Electronic Sign  
±12 x 3 ft

**30' GVEC  
Utility Line  
Clearance**

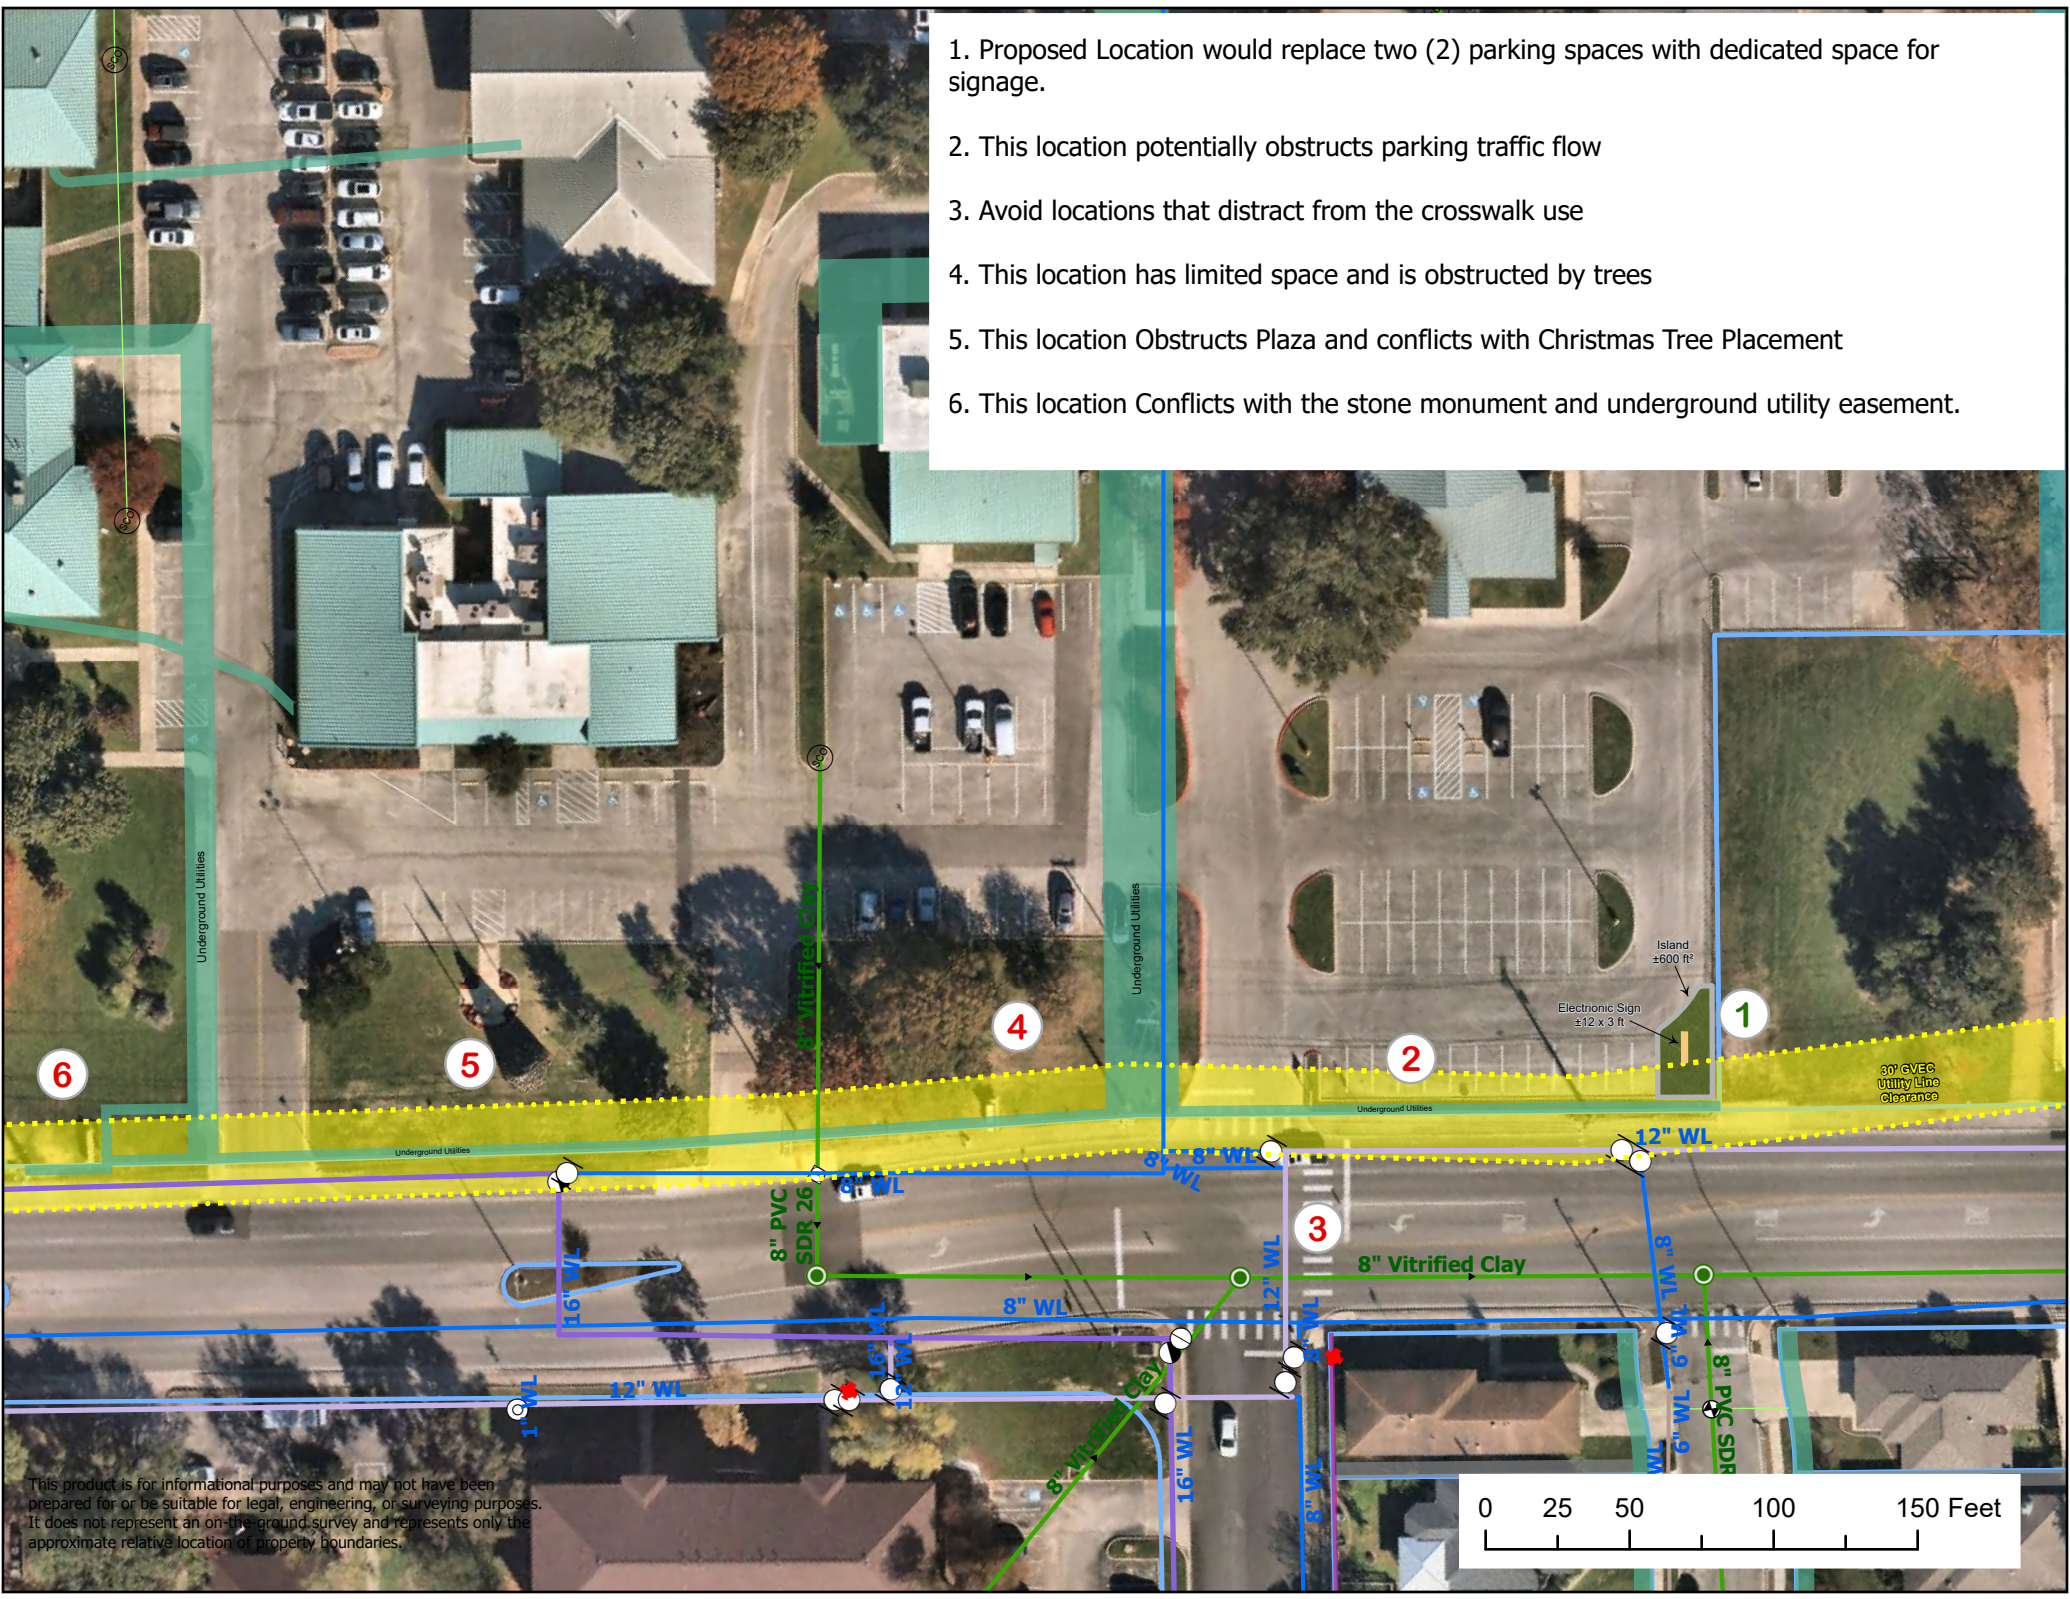
1. Proposed Location would replace two (2) parking spaces with dedicated space for signage.
2. This location potentially obstructs parking traffic flow
3. Avoid locations that distract from the crosswalk use
4. This location has limited space and is obstructed by trees
5. This location Obstructs Plaza and conflicts with Christmas Tree Placement
6. This location Conflicts with the stone monument and underground utility easement.
